Northeast Water Purification Plant (NEWPP)
Improvements Package No. 2 – High Service Pump Station
and Miscellaneous Piping Improvements
WBS No. S-000066-012A-4

ADDENDUM

ADDENDUM NO. 2

Date of Addendum: 11/16/15

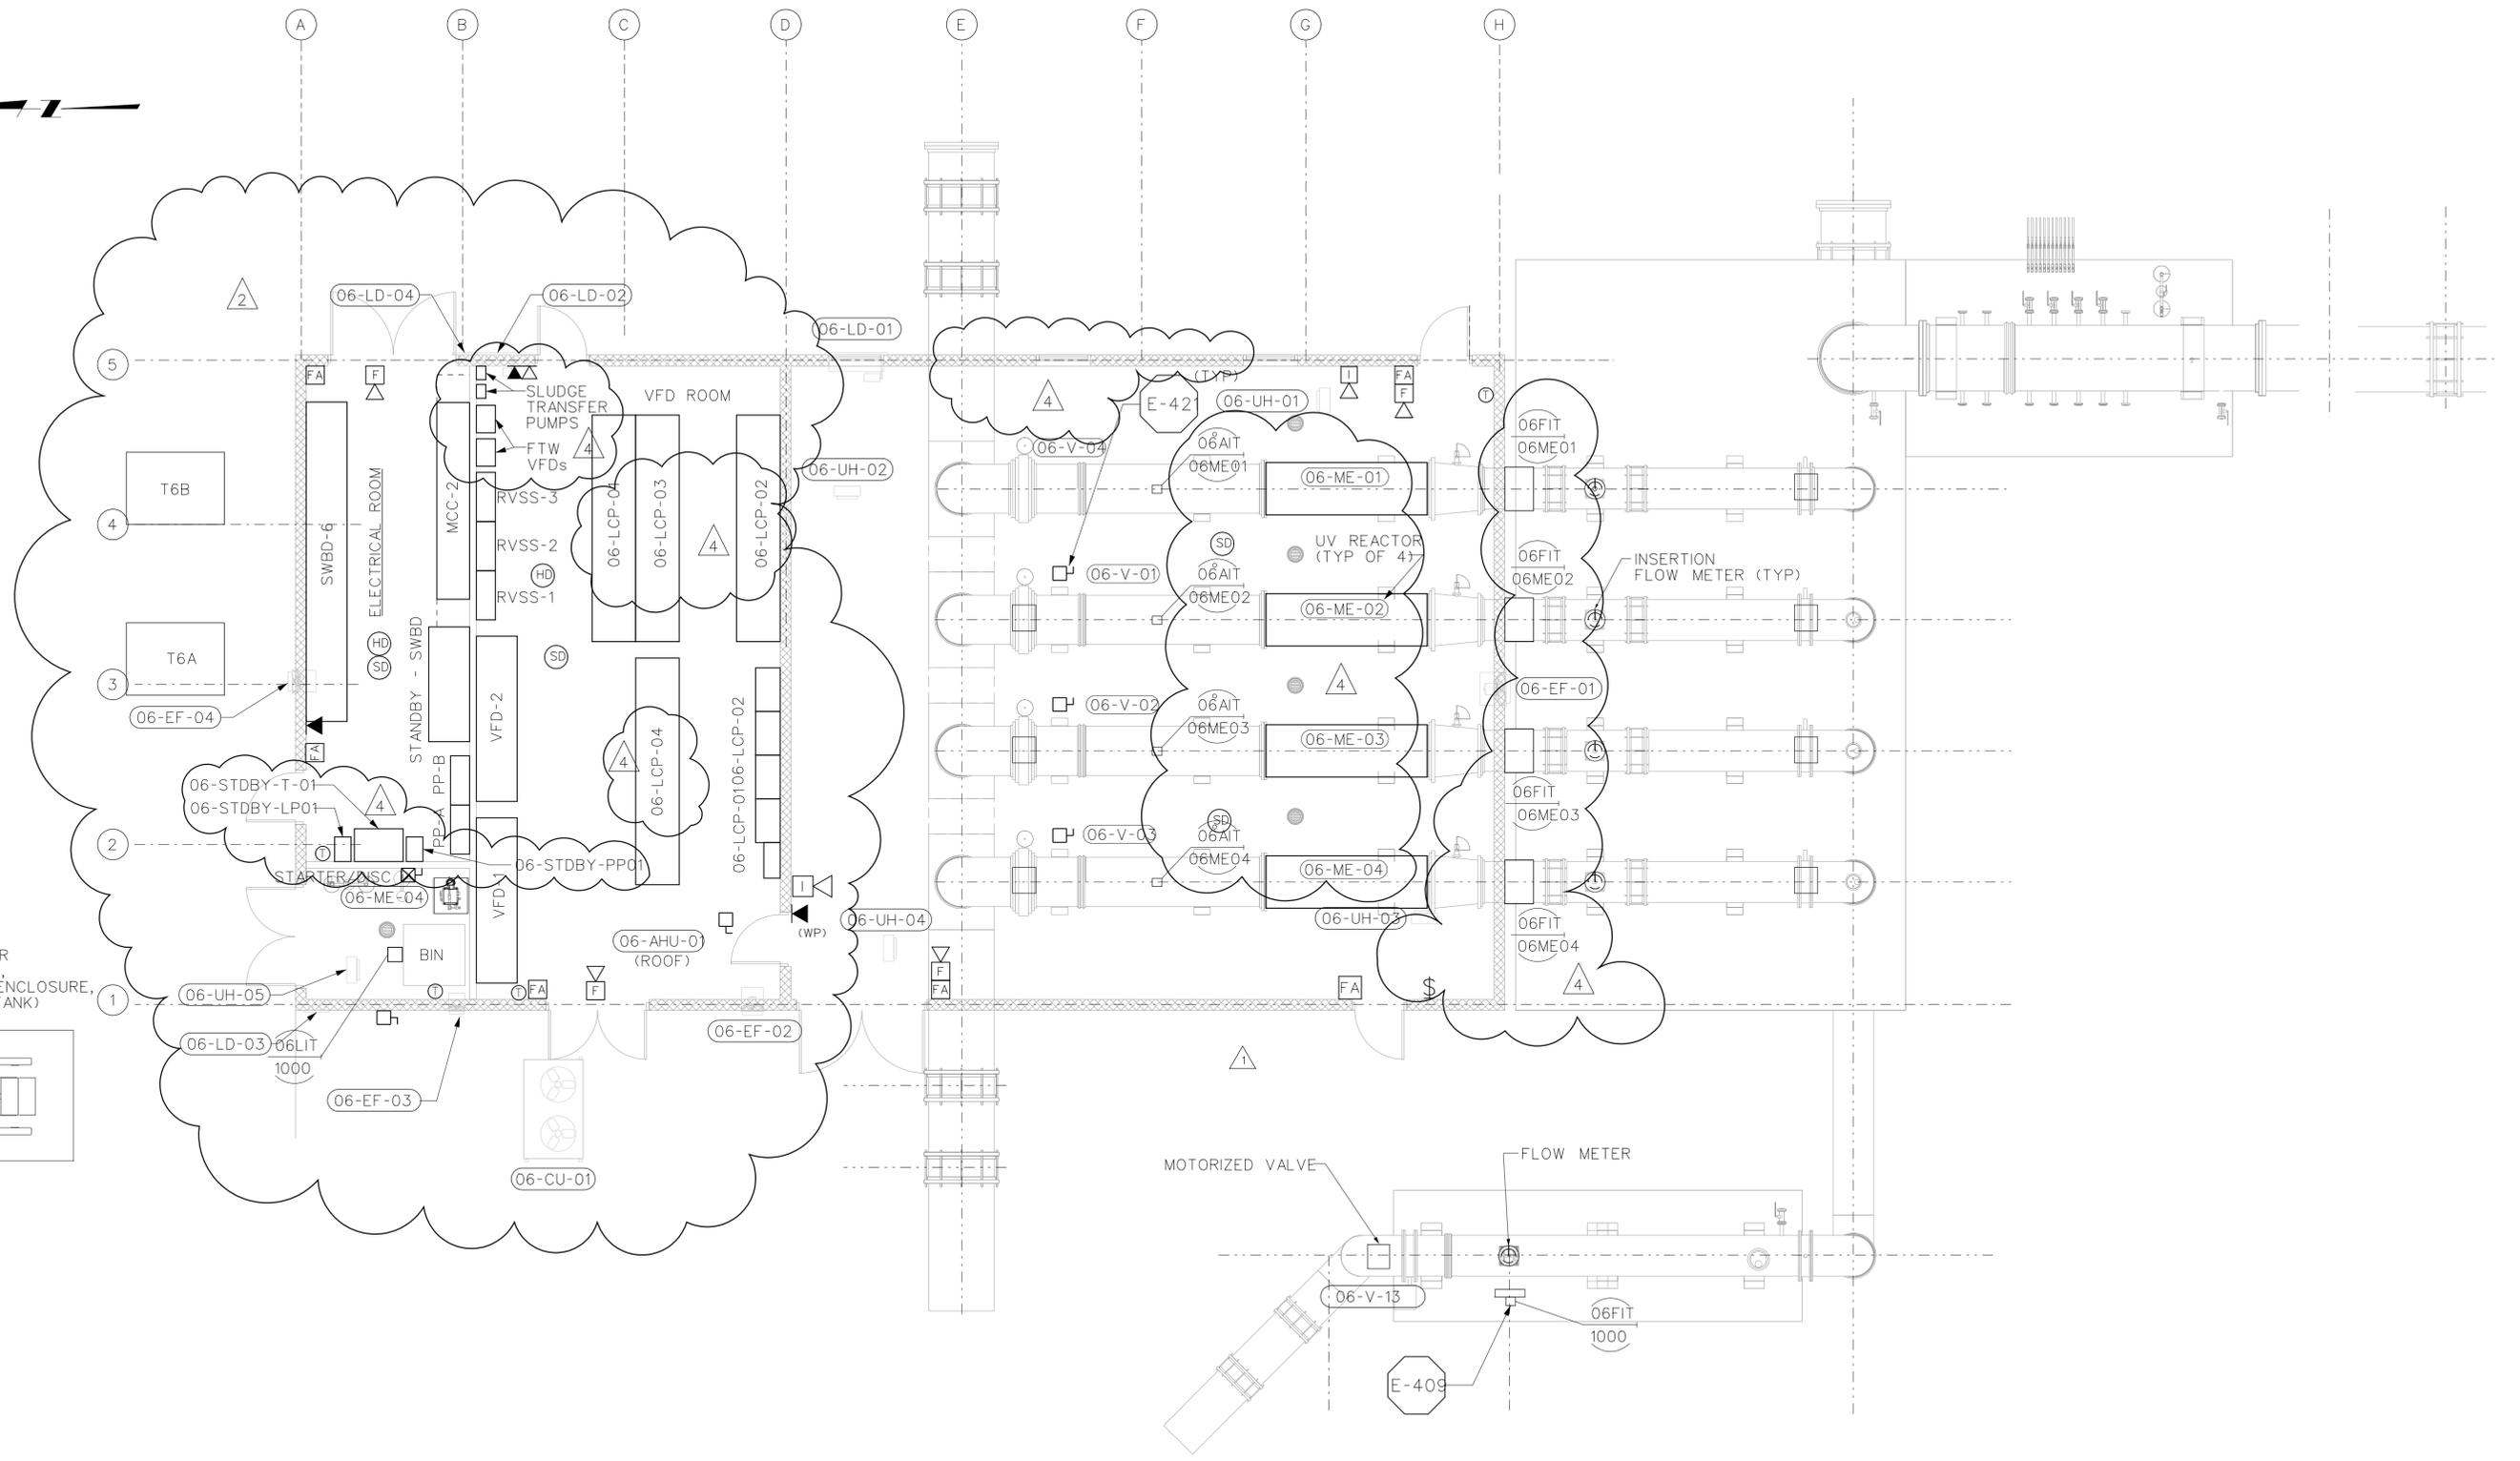
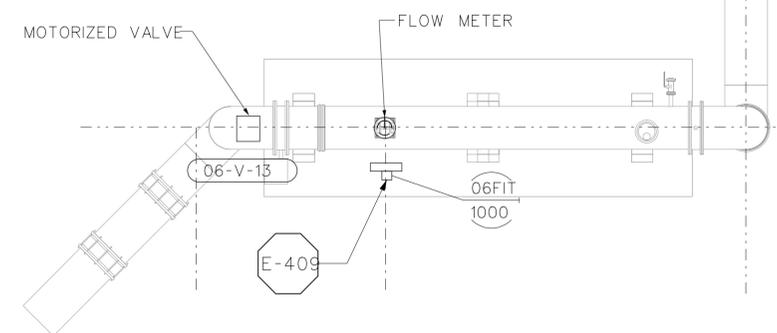
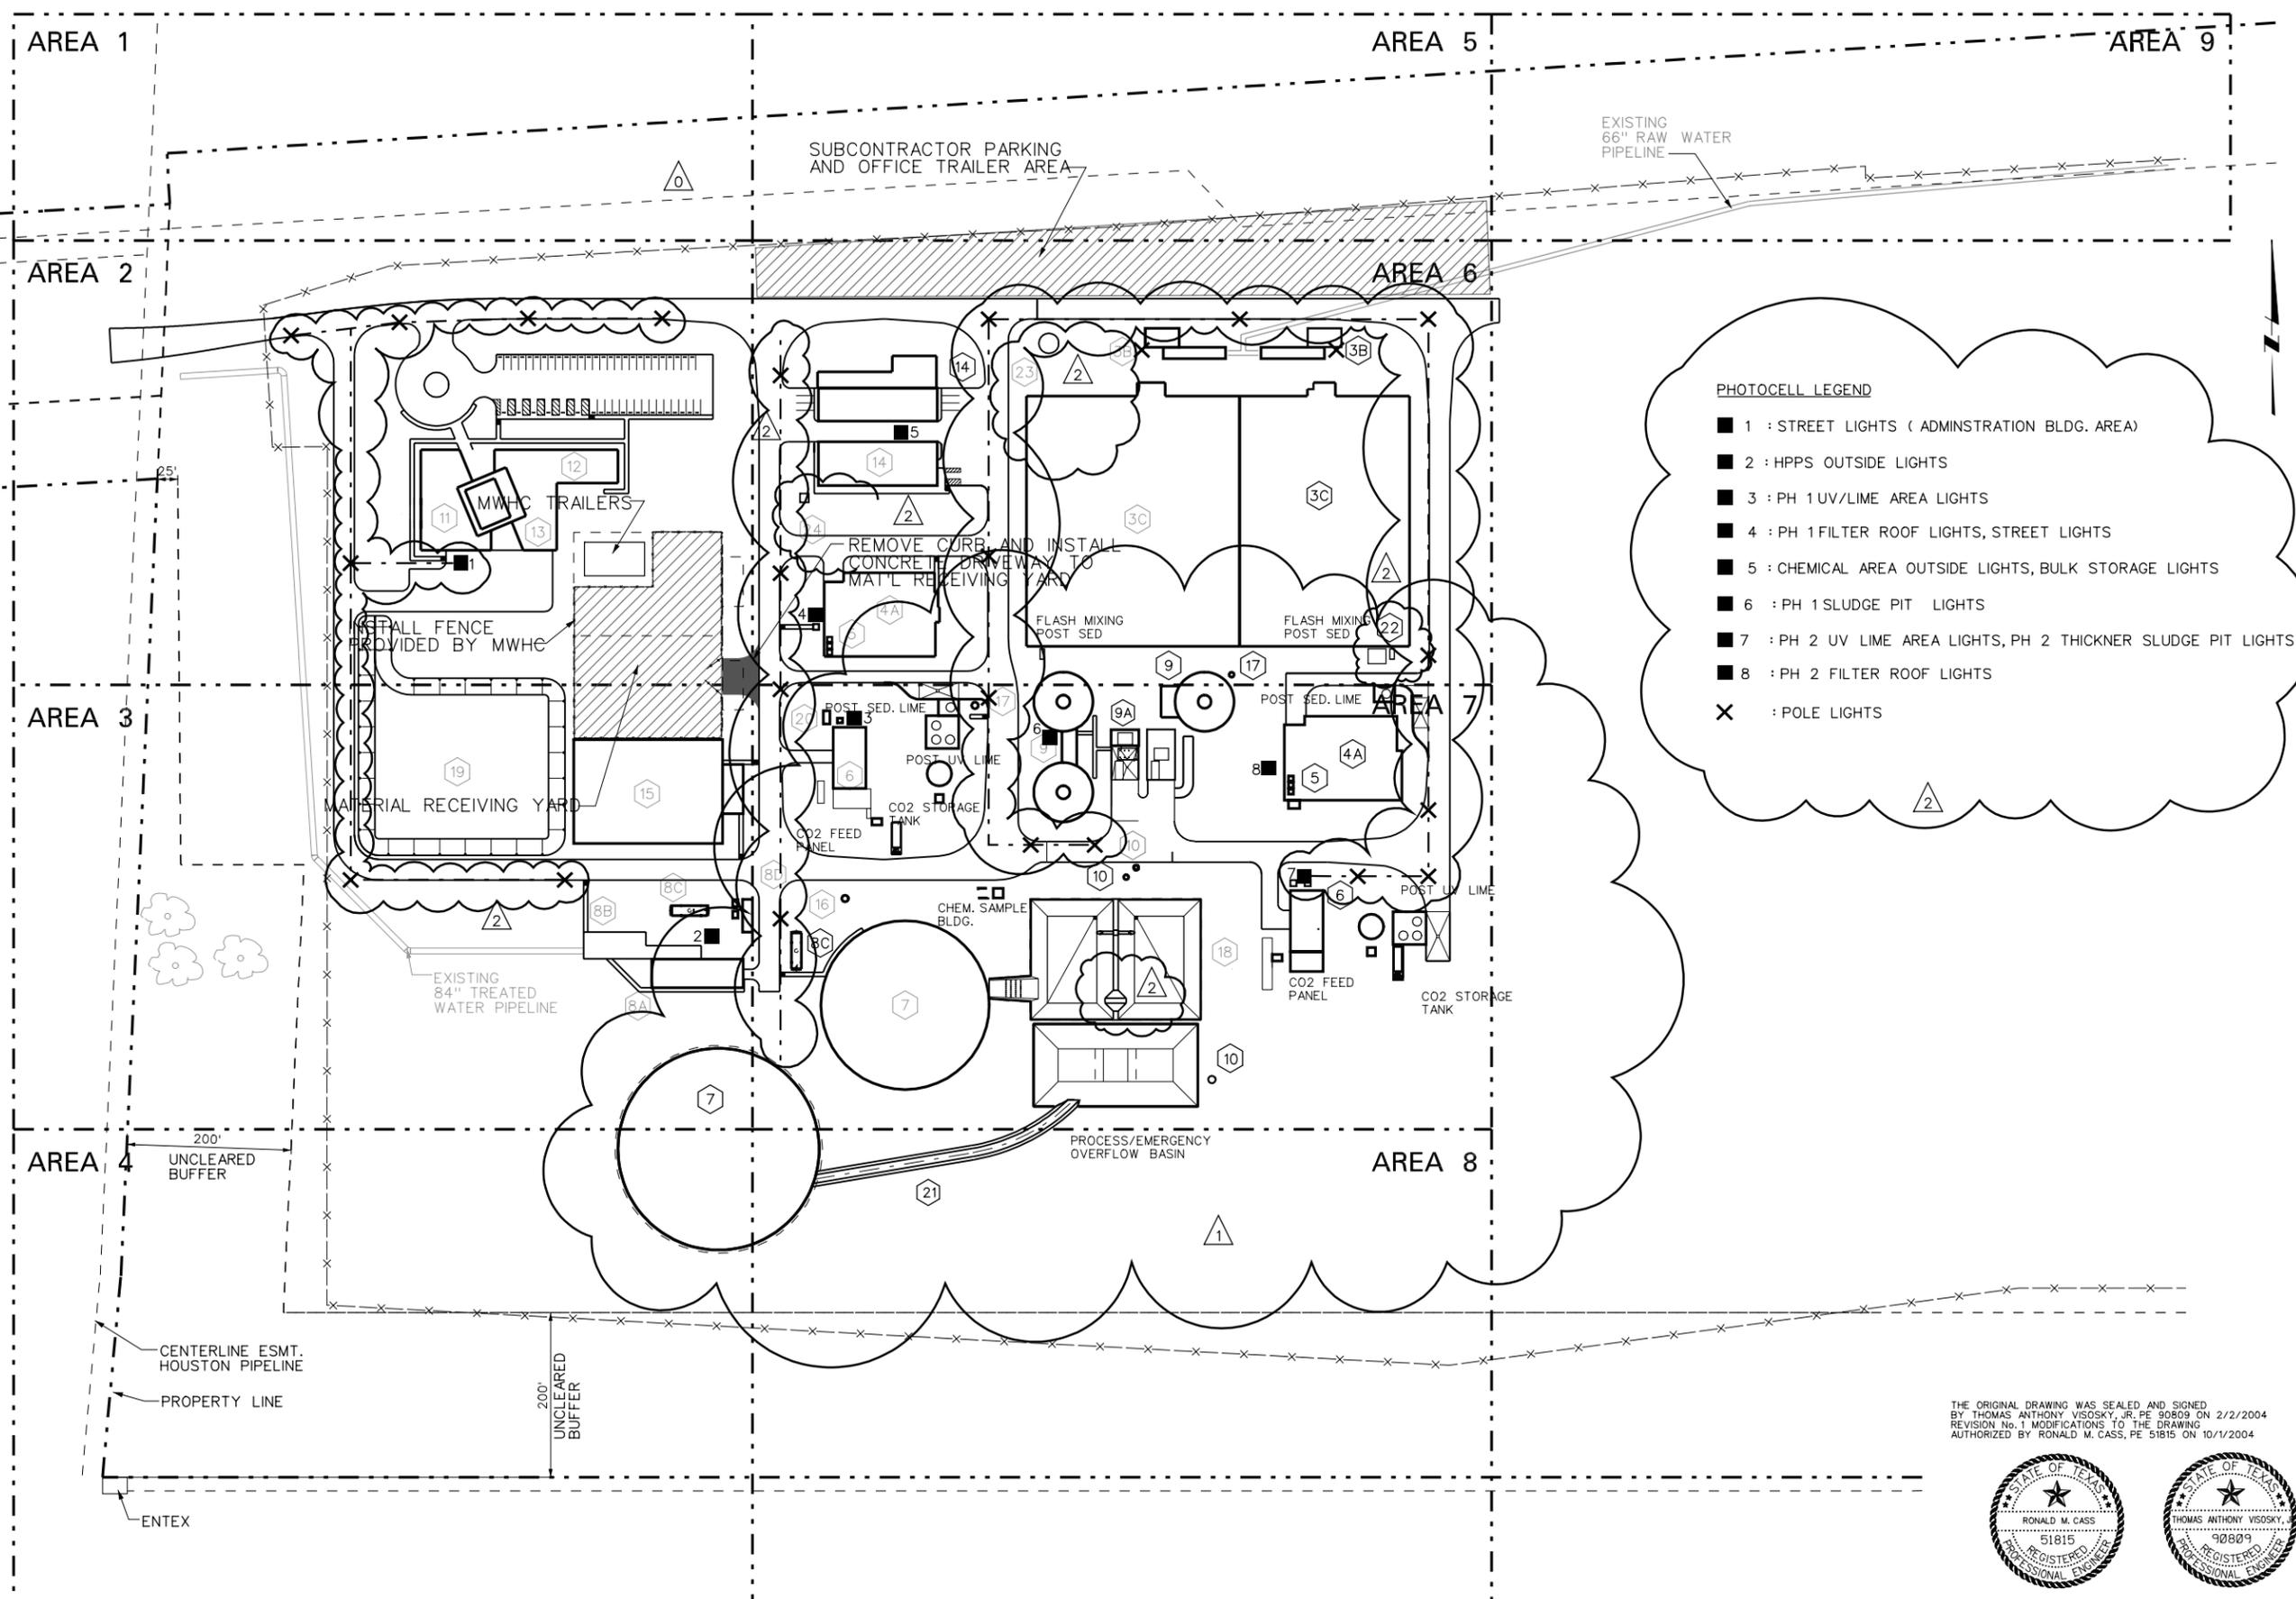
12. Question: Can you please provide electrical As-Built drawings for underground conduits around the areas where we have to make line stops & taps?

Answer: Record Drawings provided by the City illustrating this area are included to the end of this document.
